**OIL INDIA LIMITED**  
**(A Government of India Enterprise)**  
**P.O. Duliajan – 786602, Assam, India**  
**Website: [www.oil-india.com](http://www.oil-india.com)**

**Corrigendum No. 1 to IFB No. CPG8895P19**

**Engineering, Fabrication and supply of Modular Packages Contract (MPC) for OCS at Nadua and GGS at East Khagorijan in Dibrugarh District, Assam**

## Annexure- IV to Corrigendum No.1

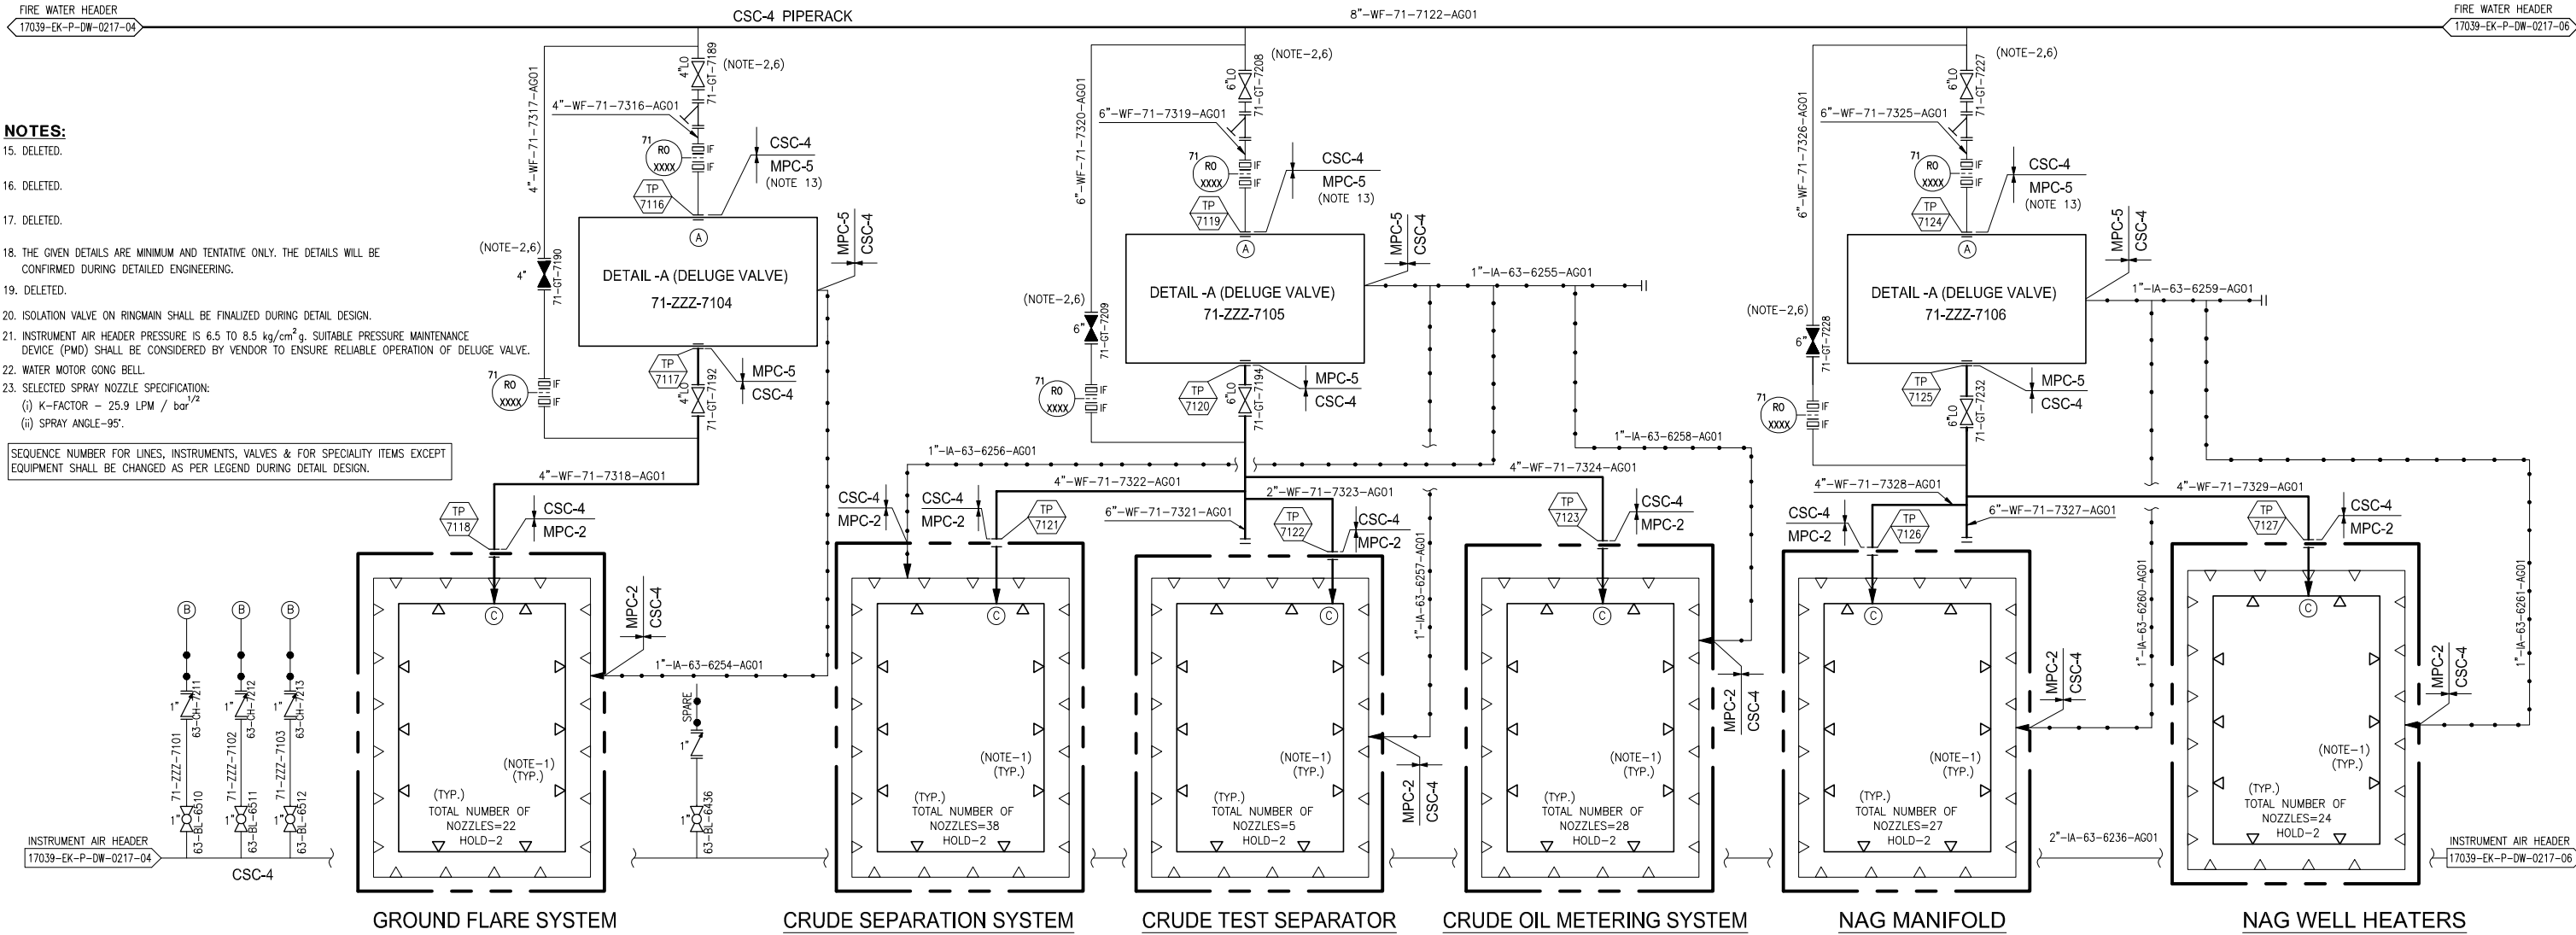
d) Deluge system piping and instrumentation diagram is attached herewith as **Annexure –IV**.

30	Section-II Part-II-Overall PFD		HP header operating pressure-28-90 Kg/cm2 LP header Operating pressure - 5-27 kg/cm2	Based on the referred document, Bidder presumes that if HP wells pressure is 27 kg/cm2 will be routed to LP header. Hence consultant HMB to be revised for the case case 3 and 4 with HP wells pressure as 28 kg/cm2 instead of 10 kg/cm2	Successful bidder to develop LP cases for less than 28 kg/cm2 incoming well fluid pressure. However given HMBT for 5-10 kg/cm2 for LP Wells govern the size of equipment, valves, etc. Refer HMBT &PID provided for design cases.
	Section -I, Process design Basis		Well arrival pressures:HP wells:10-90 kg/cm2LP wells:5-10 kg/cm2		
	Section -I, Heat and mass balance		Simulation considered LP well maximum pressure 27 kg/cm2.		
31	IFB no. CPG8895P19		Medium velocity spray nozzles are required for process skids	Bidder request OIL to provide the deluge system piping and instrumentation diagram for scope of supply consideration.	P&ID will be provided. Refer <b>Annexure-IV</b>

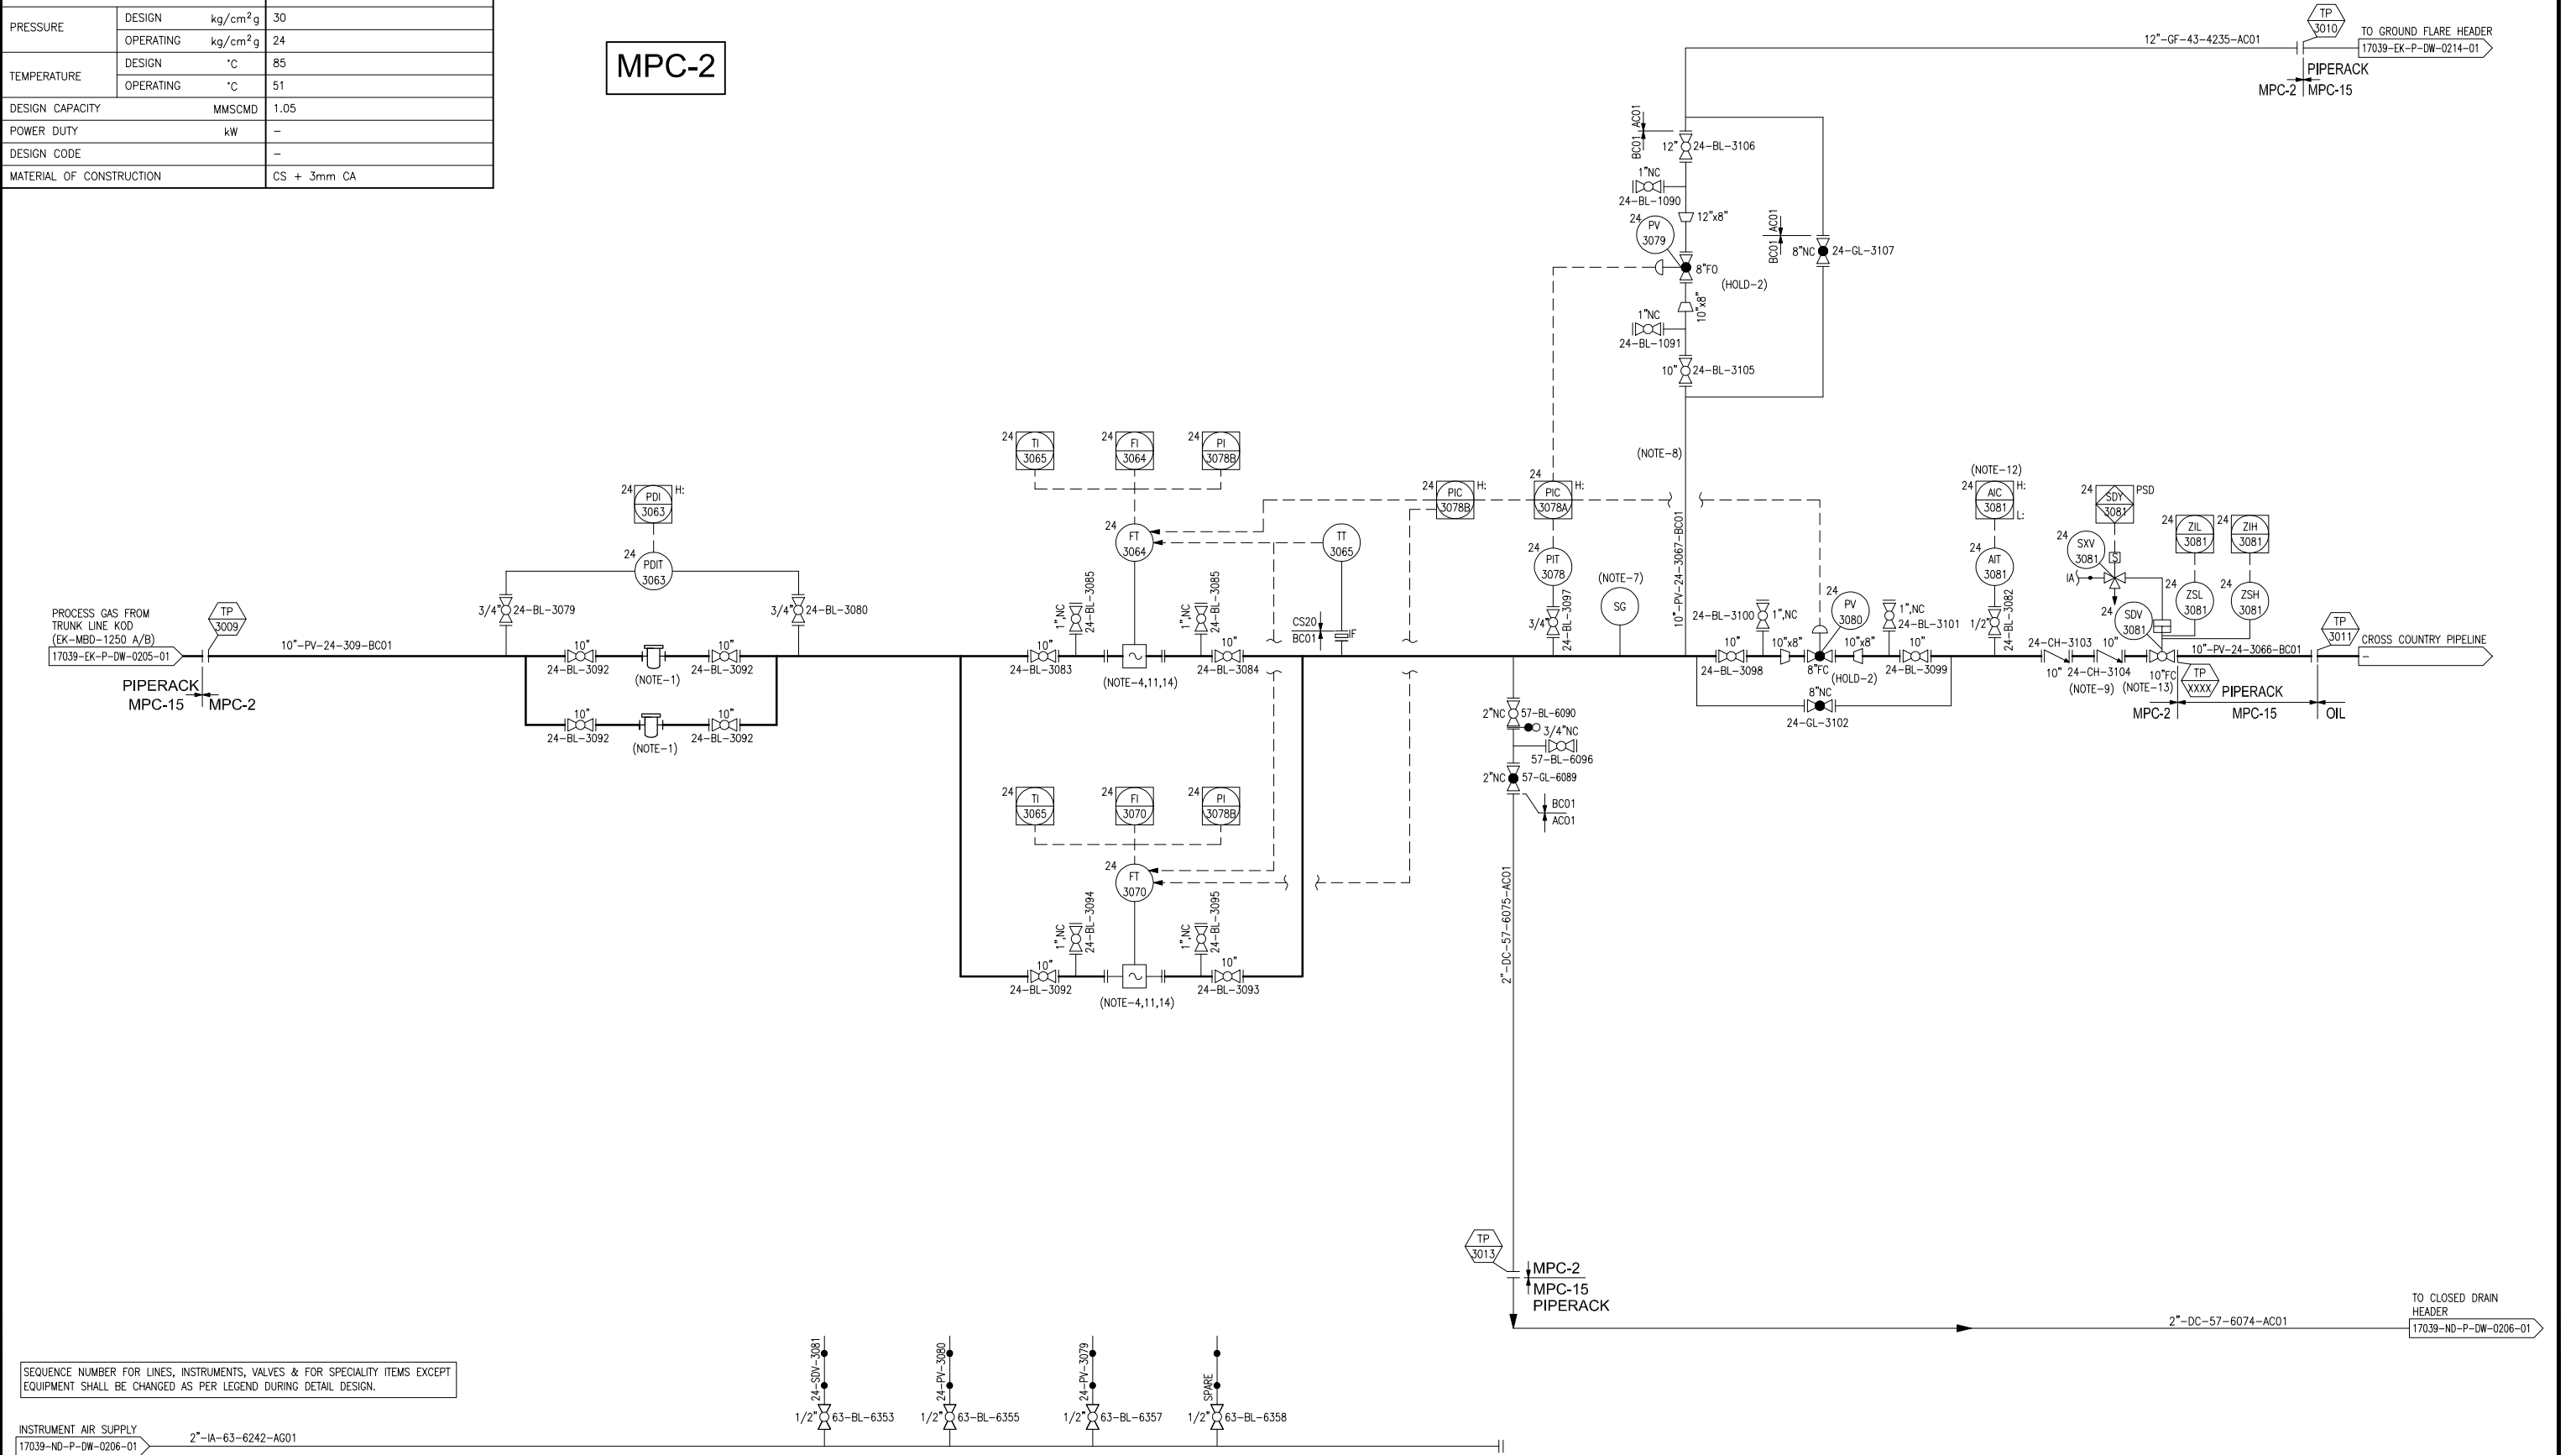
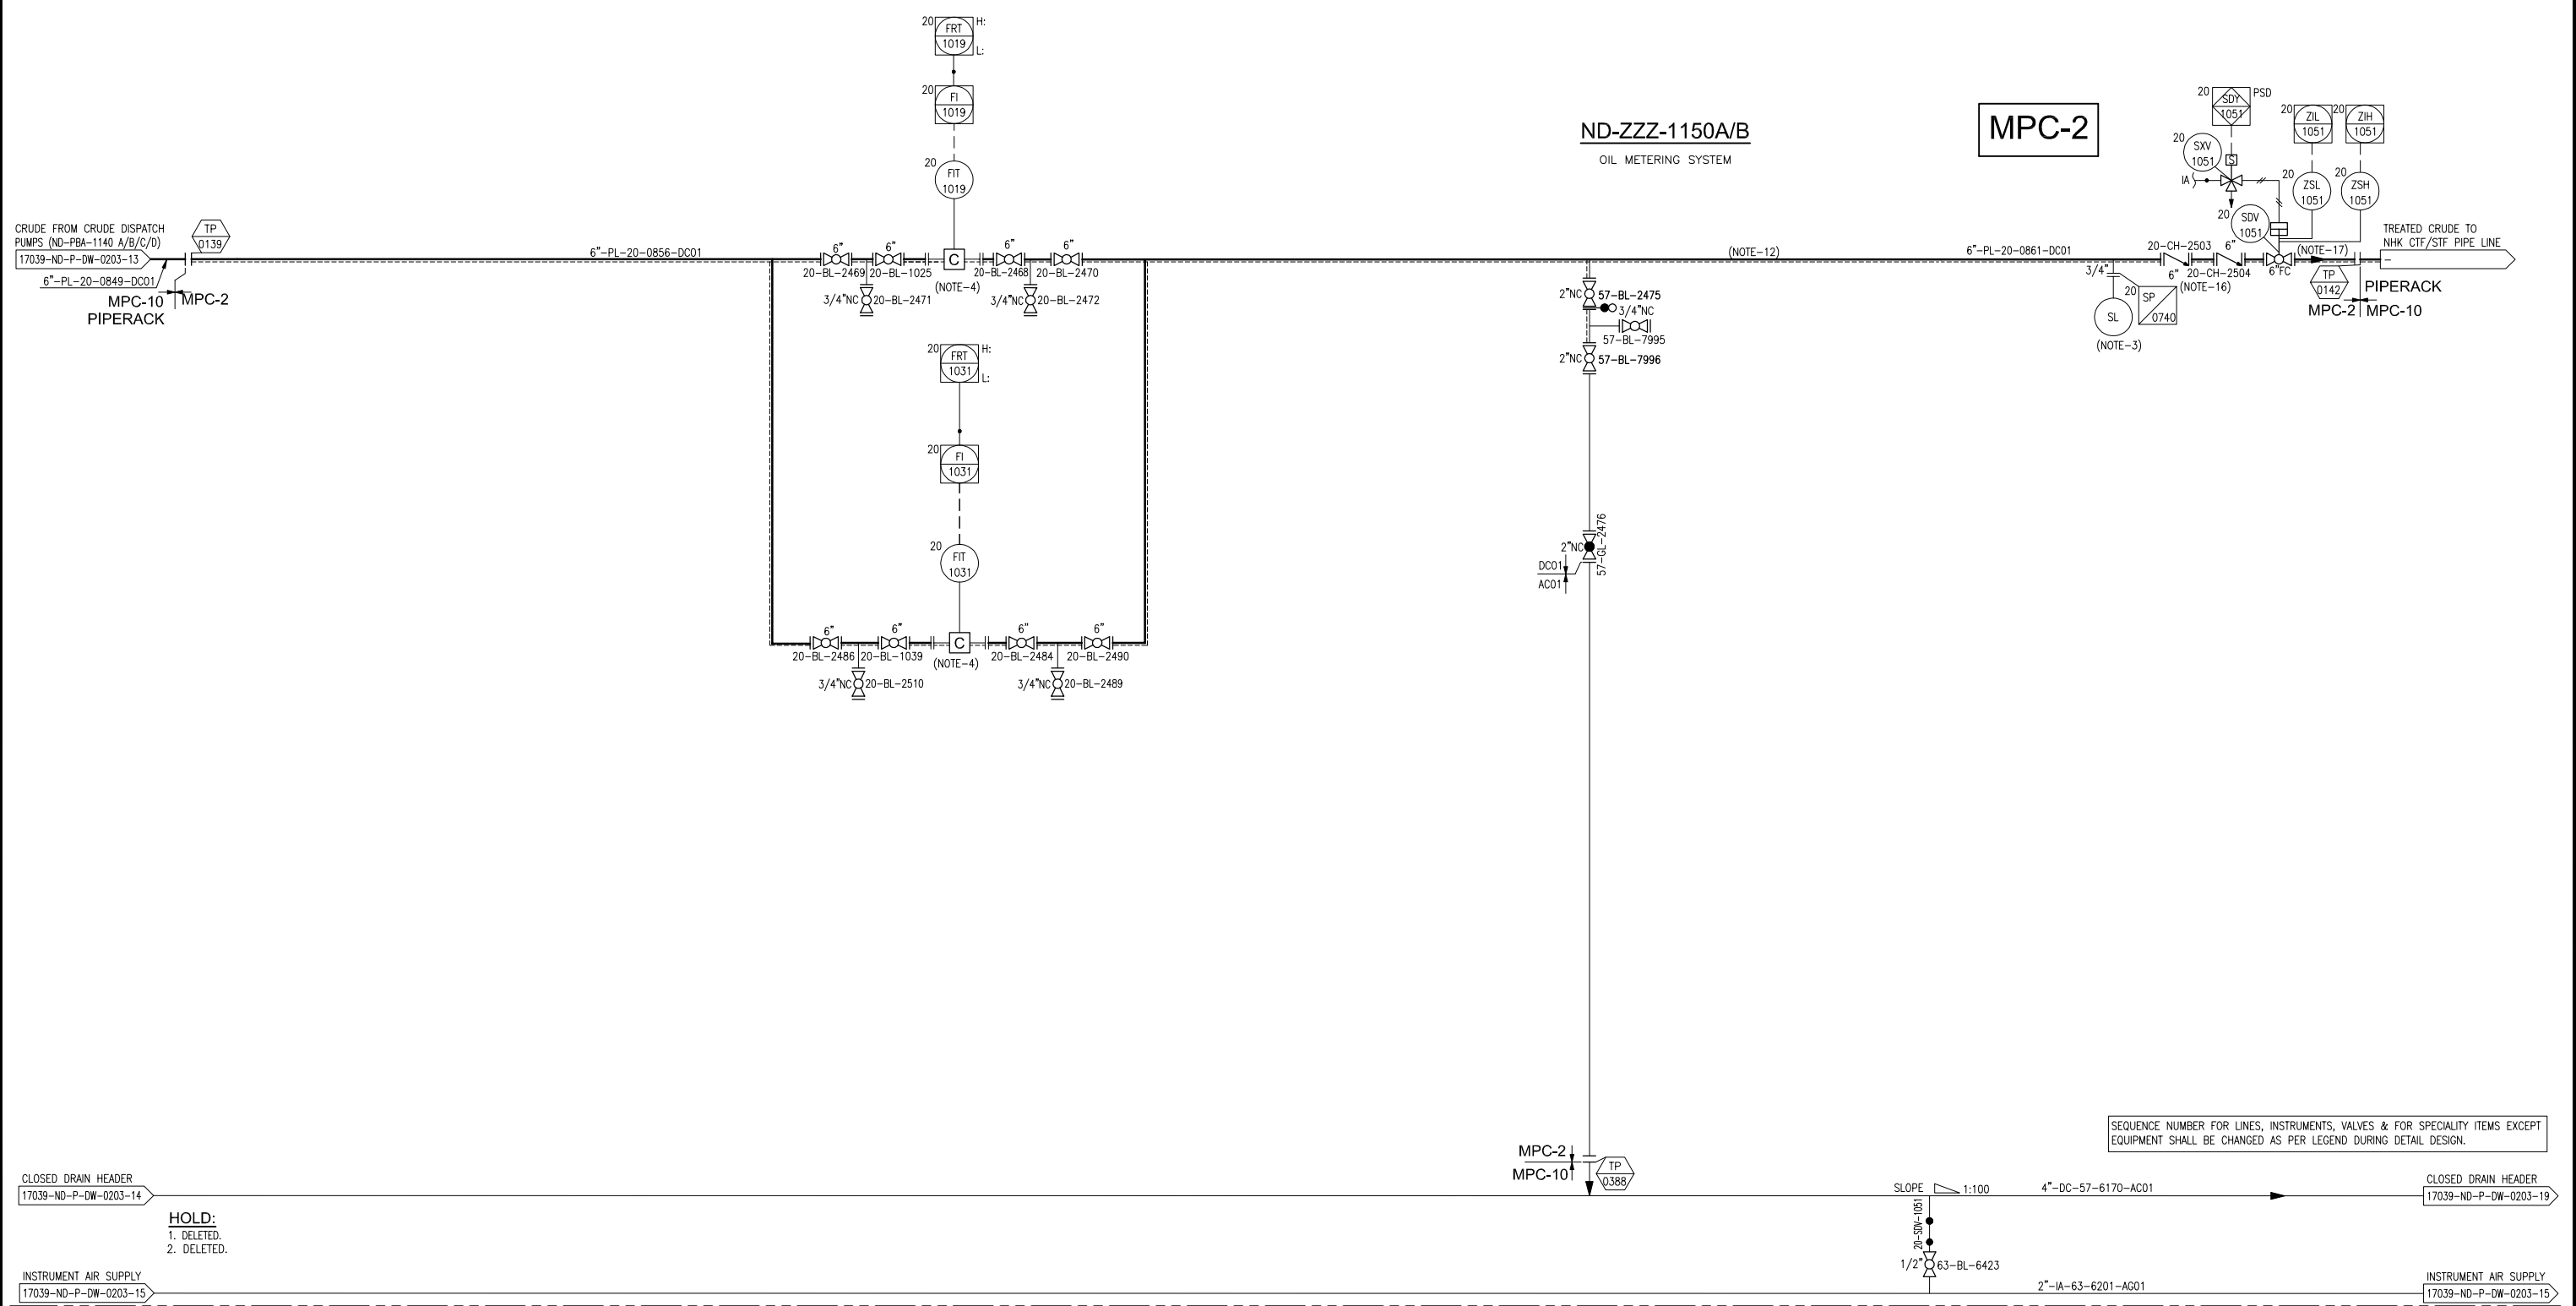
f) Revised P&ID for Oil/Gas Metering System is attached as **Annexure- VI**.
